ADDENDUM #4

January 11, 2013

Re: Harrisburg Area Community College
Central Administration – Wildwood Conference Center Renovations
Phase 2 - Demolition
Solicitation # RFB13-12

SHEET NUMBER:
A2.3

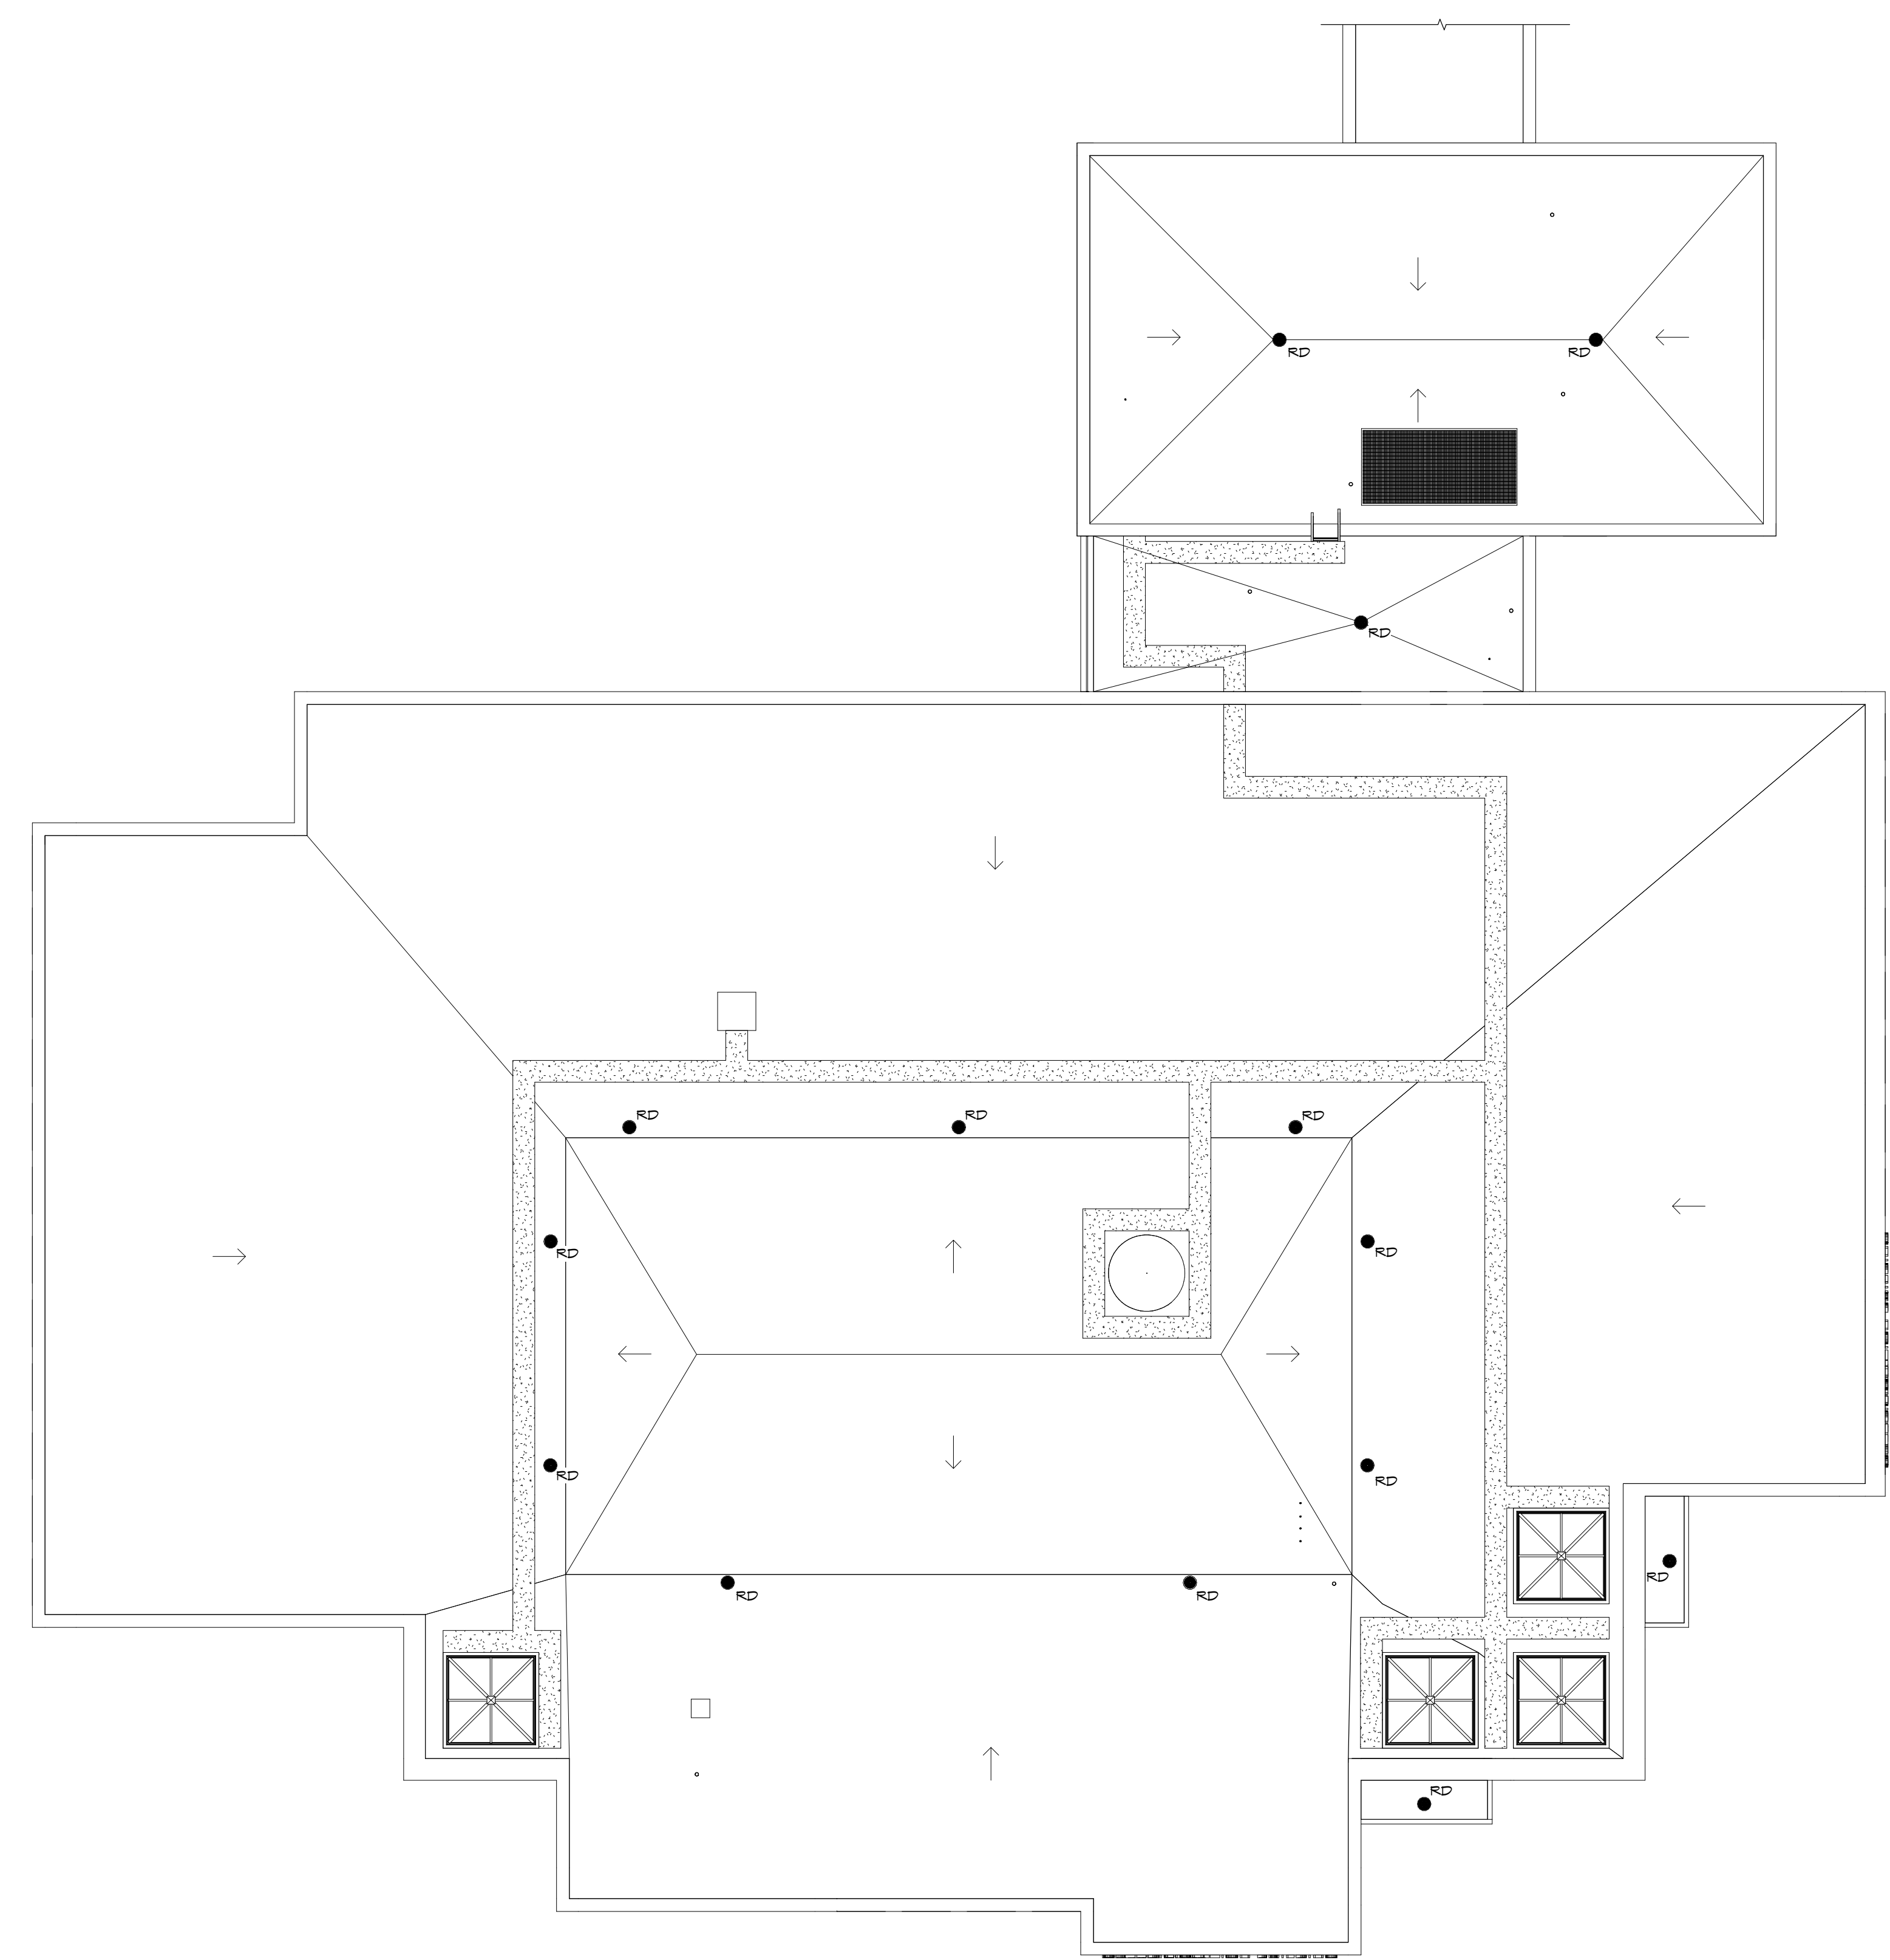
- A. Drawing X2.7 – Large Scale Second Floor Demolition Plan – Section B: REVISE drawing per SKA-3.
- B. Drawing X2.8 – Large Scale Roof Demolition Plan – Section A: REVISE drawing per SKA-4.
- C. Drawing A2.3 – Roof Plan – Composite – New: REPLACE this sheet in its entirety.

ENTIRE SHEET HAS BEEN MODIFIED
